Product Change Notification: PCN-22-156615

Deutsch DTM13 Family Housing Design Change

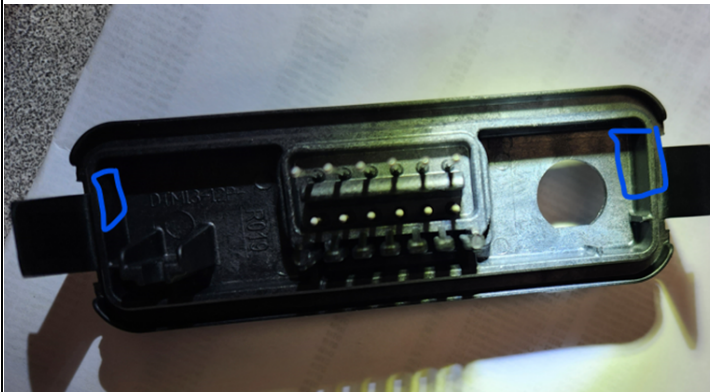
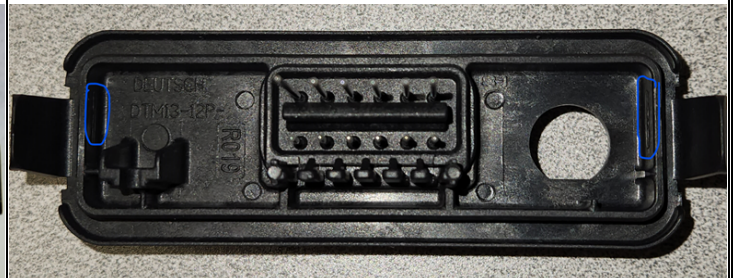
The Industrial and Commercial Transportation business unit of TE Connectivity is making a change to the design of a noncritical feature for the part number(s) listed below. These PNs are TE proprietary designs, therefore considered catalog/general market product. PPAP and/or sample requests must be submitted within 14 days of PCN submission via ict-ppap-request@te.com or ePPAP system. Submission will not occur without request. If PPAP requested, disposition response is required within 14 days of submit date or it will be considered approved. Product drawing(s) are affected.

No Pullers

Pullers

No Pullers Full Part

With Pullers Full Part

Dear Customer, we hereby inform you of this change. The change is necessary to improve the molding process. The change does not impact performance. IMPORTANT: The current and previous revisions of these parts can be used interchangeably in the field. The change(s) are being phased in gradually and previous revision can remain stocked until use. Shipments of both configurations may be mixed.
